LiDAR Quality Assessment Report

VA_FEMA-lidar-Lot7_2011

FEMA Virginia LiDAR

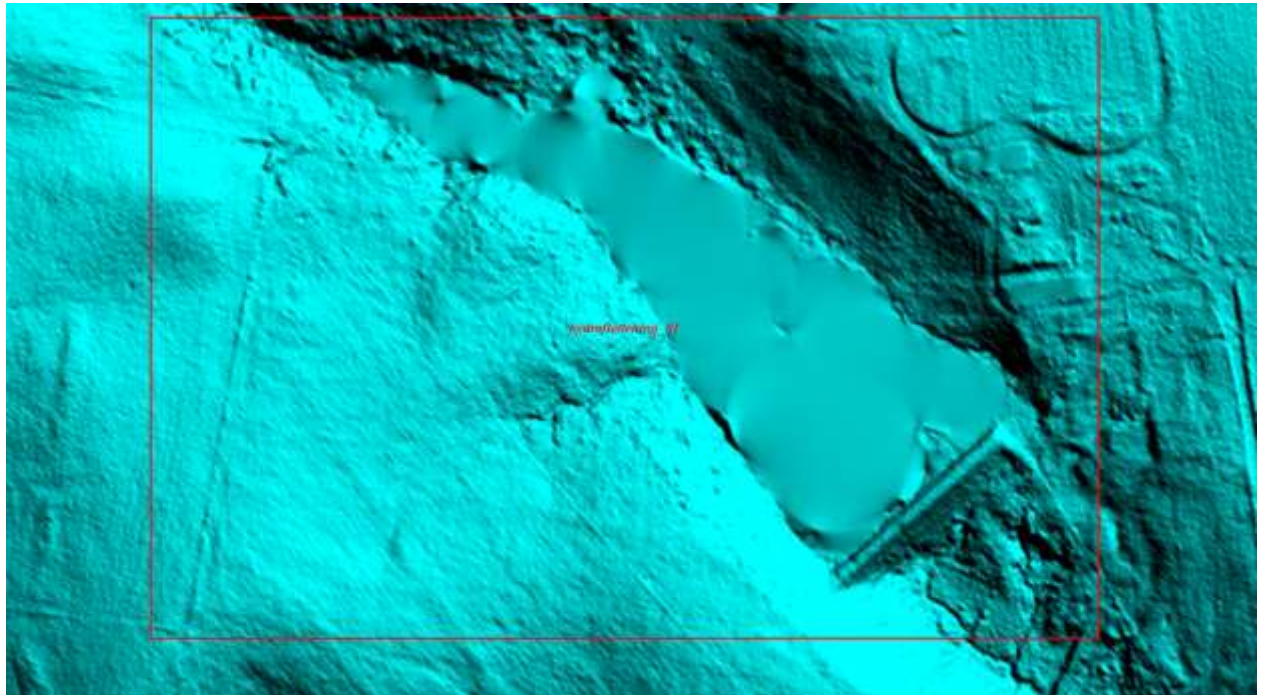
There are two bridges that were not removed; although, it appears that an attempt was made. The bare-earth surface is not represented in the DEM for this reason. (bridge_removal_01 & bridge_removal_02) BRIDGE REMOVAL WAS NOT ADDRESSED, SEE FOLLOWING EXPLANATION:

"The USGS identified two occurrences where it appeared bridges or portions of bridges were left in the bare-earth surface. Dewberry reviewed these bridges and verified that no bridge points were left in the ground surface. The DEM surface models are created from TINs or Terrains. TIN and Terrain models create continuous surfaces from the inputs. Because a continuous surface is being created, the TIN or Terrain will use interpolation to triangulate across a bridge opening from legitimate ground points on either side of the actual bridge. This can cause visual artifacts or "saddles." These "artifacts" are only visual and do not exist in the LiDAR points or breaklines. No points were modified at these locations."

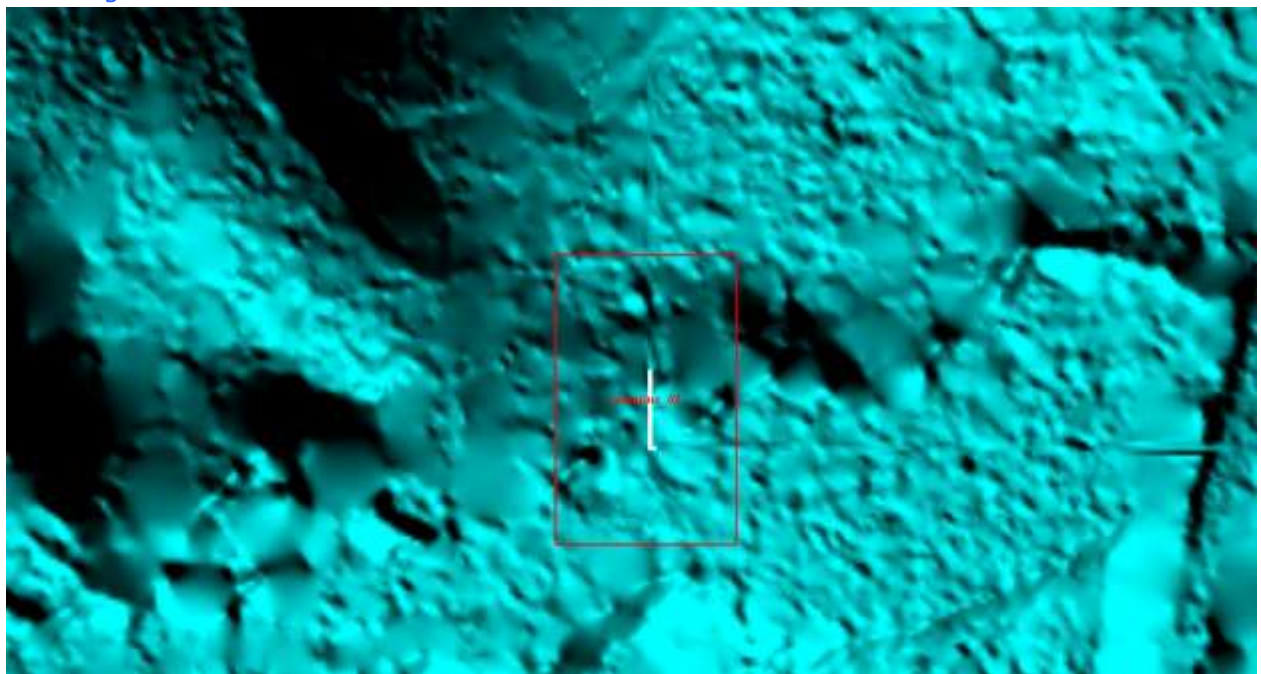
There are five water bodies that are greater than two acres in size, and have not been hydro-flattened. (hydroflattening_01 - hydroflattening_05) ALL HYDROFLATTENING ERRORS HAVE BEEN CORRECTED. (10/22/2012)

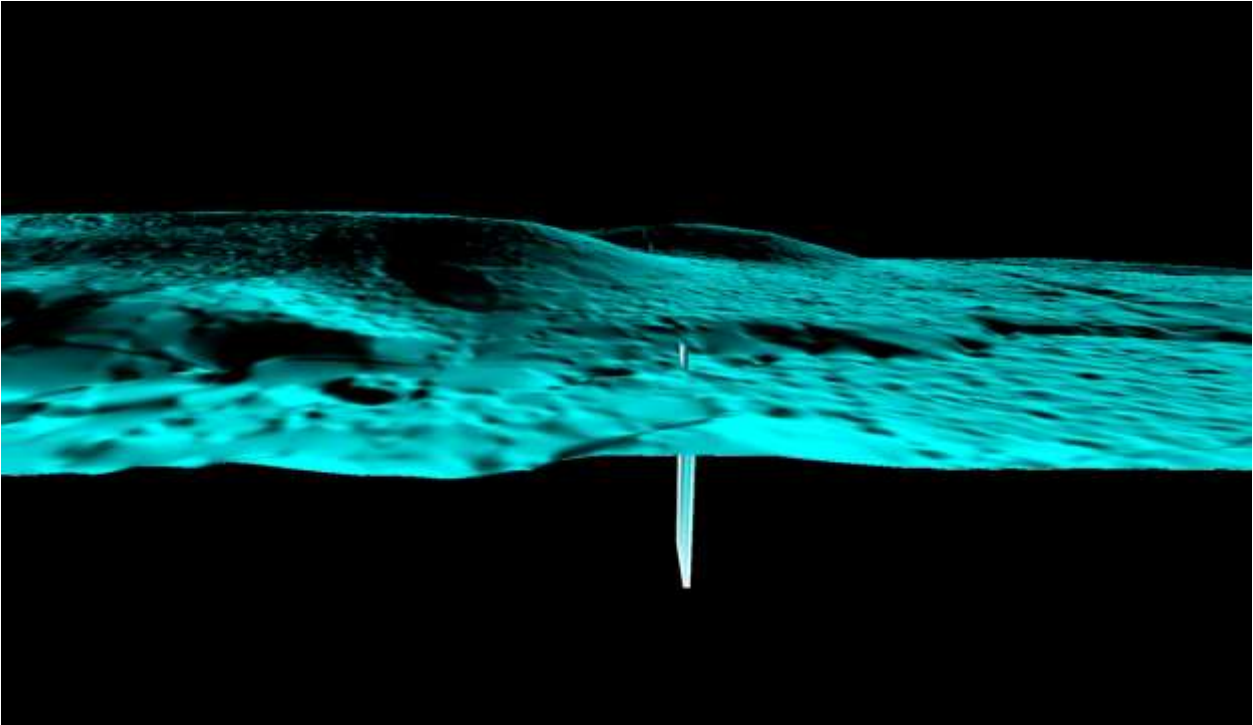
There are two seam lines where the DEM tiles do not properly edge match, giving the impression of a pit. (seamline_01 & seamline_02) ALL SEAMLINE ERRORS HAVE BEEN CORRECTED. (10/22/2012)
